In the Matter of)
) Docket 50-344
PORTLAND GENERAL ELECTRIC COMPANY,)
et al) (Control Building Proceeding)
)
(Trojan Nuclear Plant))

Trojan Nuclear Plant
Docket 50-344
License NPF-1

RESPONSE TO
OCTOBER 31, 1978
QUESTIONS FROM THE
NUCLEAR REGULATORY COMMISSION

November 1, 1978

FIGURE 4-1

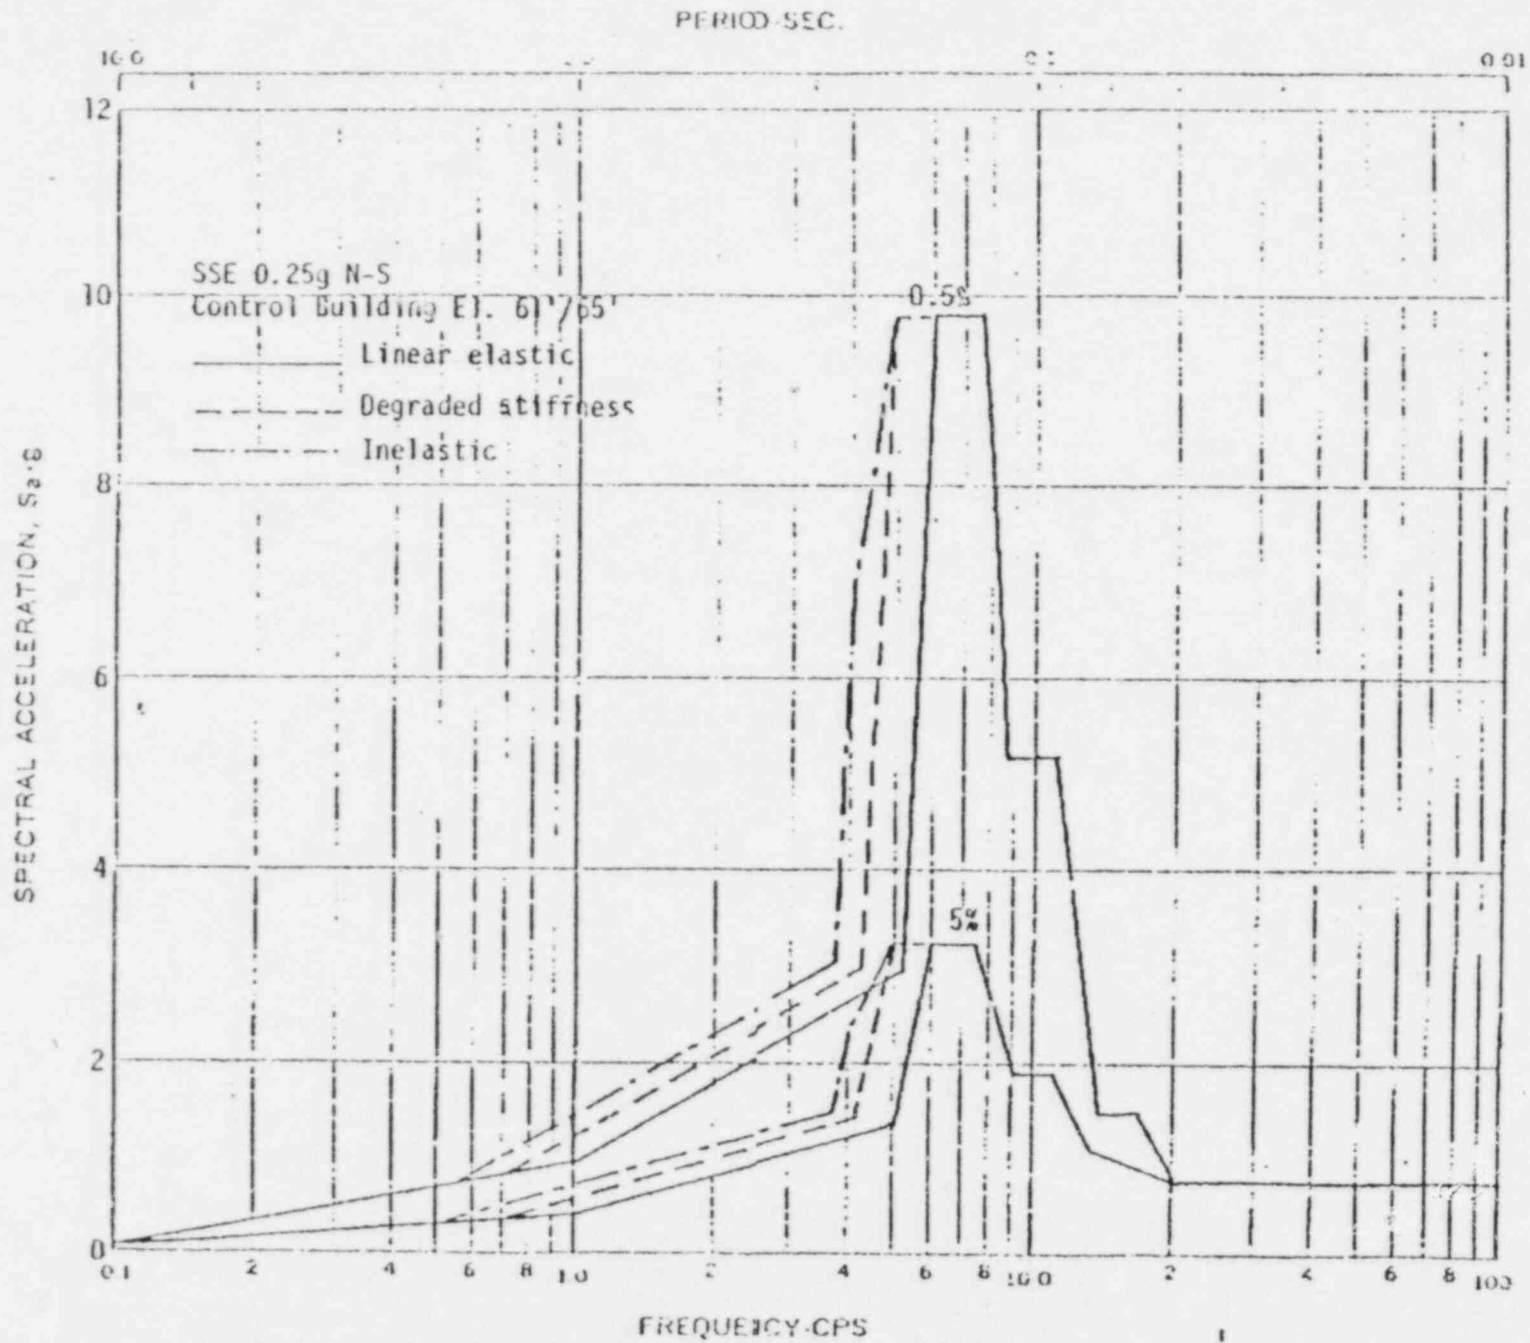
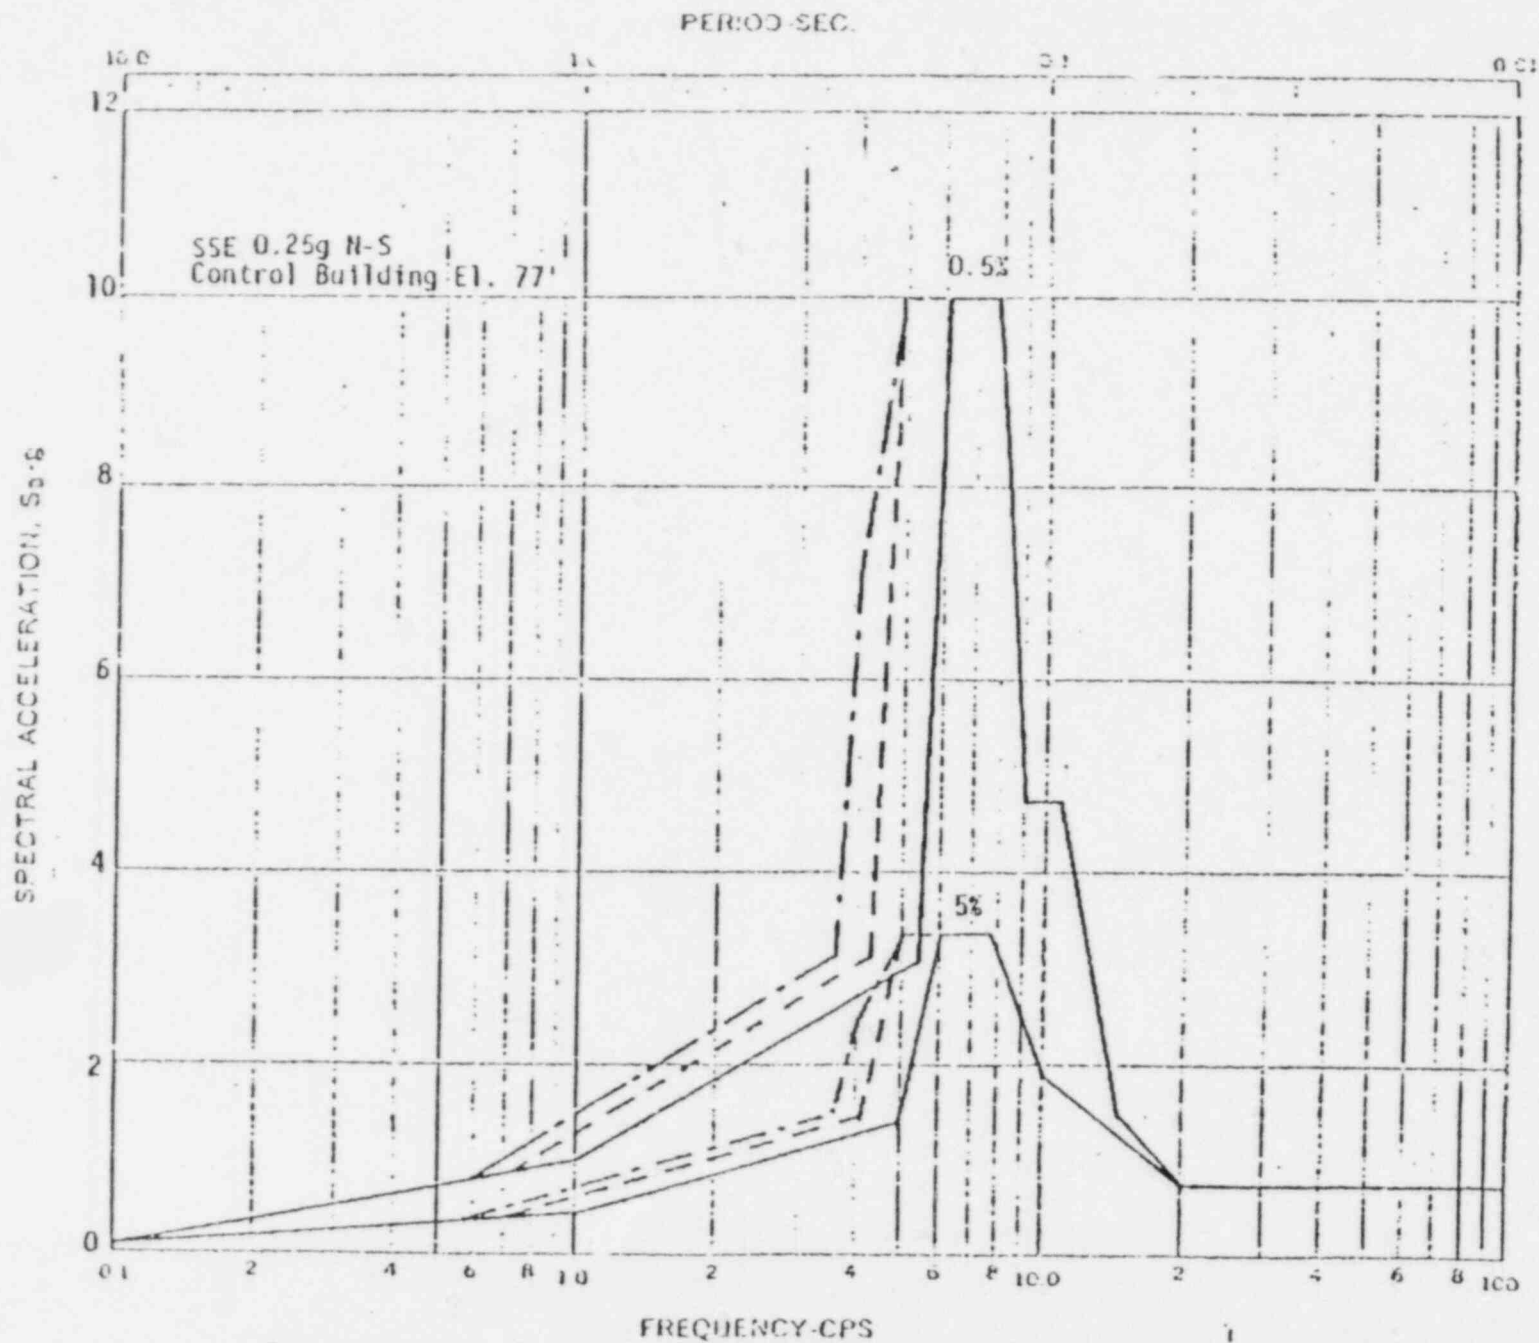
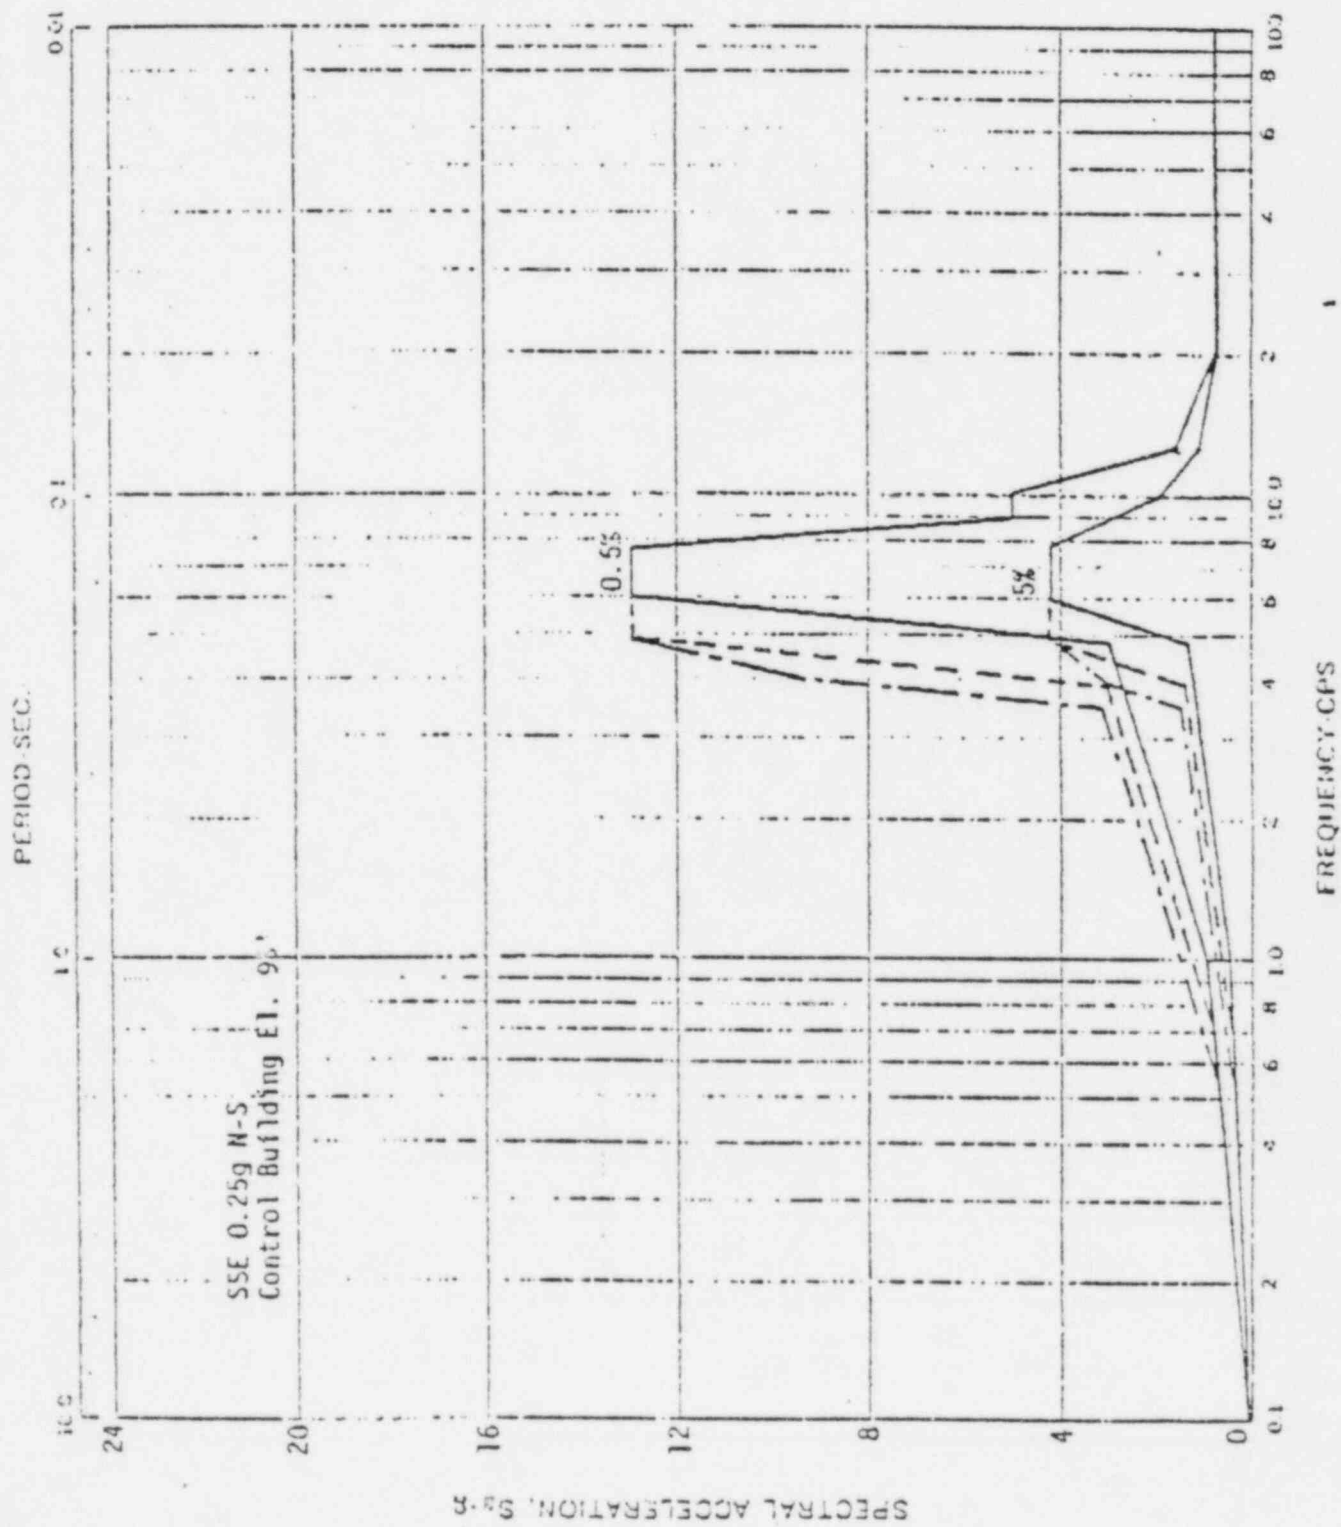
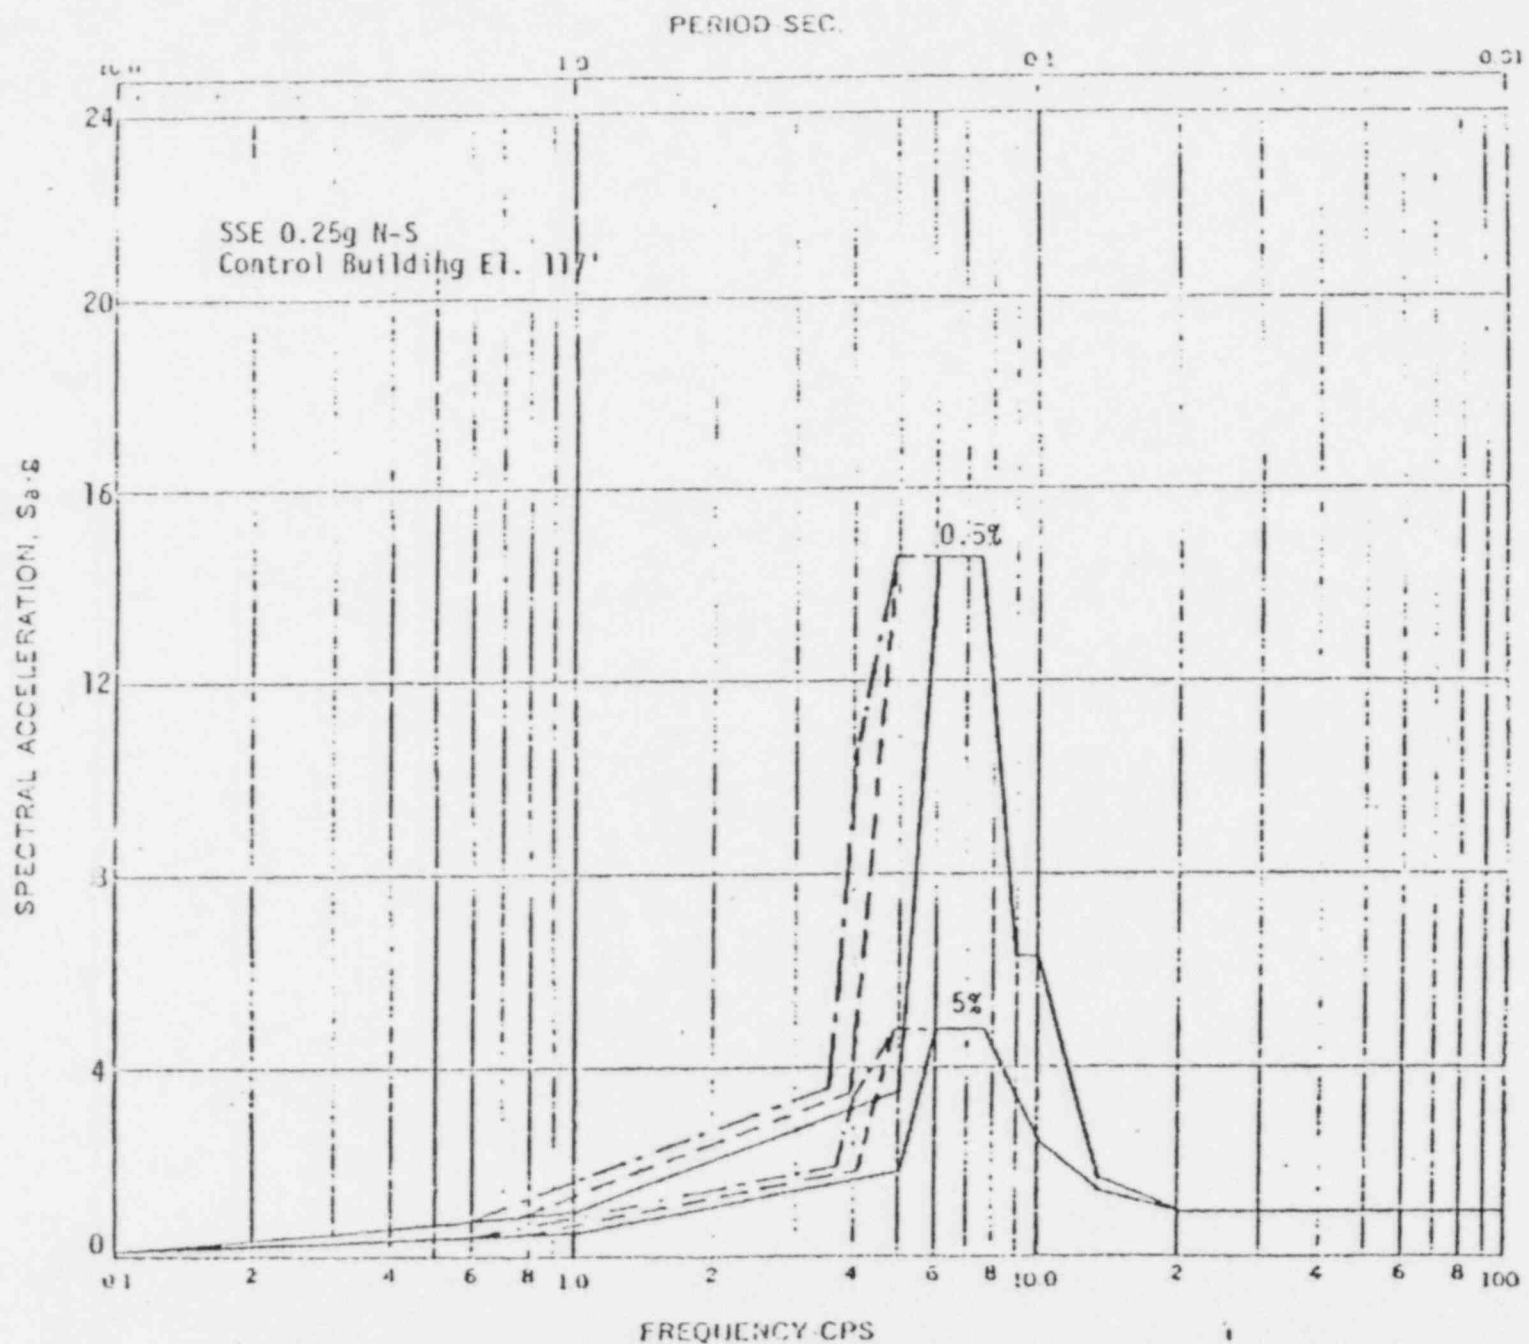
Delineate and quantify the various factors (e.g. mass and material property variations) considered in the development of the response spectrum peak broadening criteria for the linear, the degraded stiffness, and the nonlinear (those considering ductility) curves to verify their adequacy to account for any uncertainties in the analytical procedures. Also, rather than the "steps" in the spectra considering the frequency shifts due to ductility, the transition should be gradual between the frequency corresponding to zero ductility and the frequency corresponding to a ductility of 1.5. Therefore, consider this and indicate the impact on your analyses. Additionally, consider the effects of the Control Building's ductility on the Auxiliary and the Fuel Building responses.

The steps in the Control Building N-S floor response spectra shown in broken lines correspond to the upper bound ductility ratio of $\mu = 1.5$. If the ductility ratio is assumed to vary between 1.0 and the upper bound value of 1.5, the following reduction factors in spectral peak frequency and peak magnitude result:

Using the above factors, Figures 11 through 14 of the October 27, 1978 submittal can be re-plotted. The resulting spectra are shown in Figures 4-1 through 4-4. These revised response spectra have no impact on the results of analyses.

Figure 5-1 Qualitative Definition Of SECANT Modulus

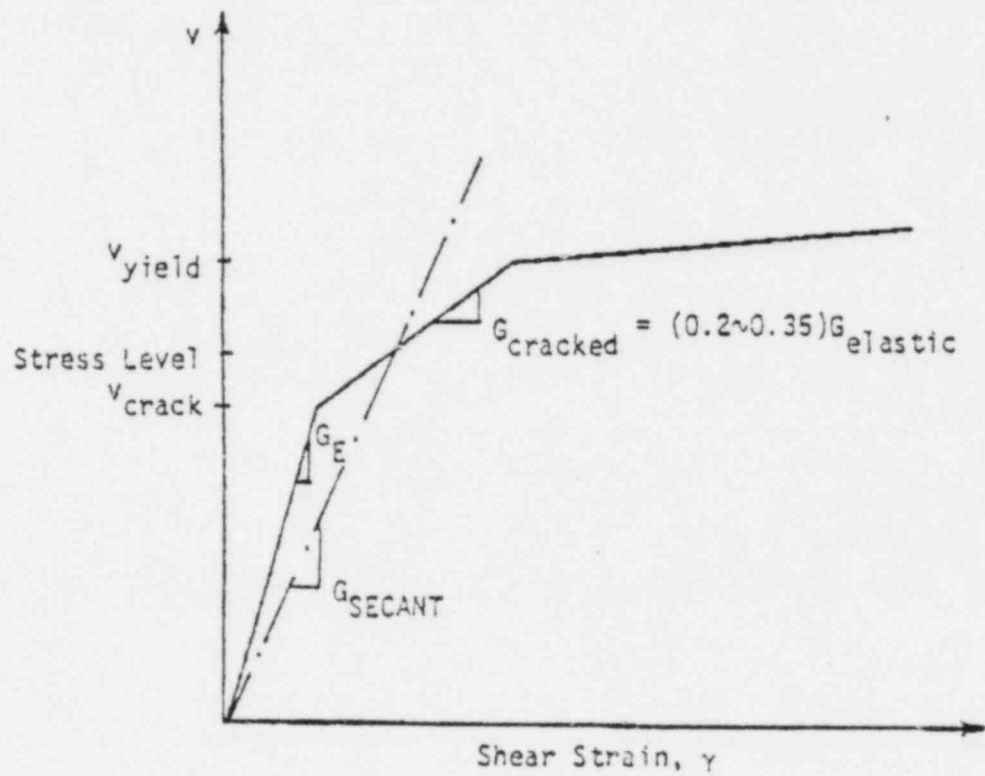
State the moduli of elasticity and the Poisson's ratios for the various floor slabs and wall types in the linear elastic STARDYNE analyses and provide your bases for these properties. Also, provide justification for the stiffness degradation factors reported in Table 4 (i.e., provide the relationships between stiffness degradation vs load for the various floor slabs and wall types corresponding to their location in the building complex) considered, and the bases for these relationships.

For the quasi-nonlinear analysis performed, the stresses that result from the analysis are the maximum stresses the walls experience during a very short duration of the response to a time history of an earthquake. Therefore, the reduced stiffness used in the analysis is the SECANT modulus as against the instantaneous stiffness. This is shown qualitatively in Figure 5-1.
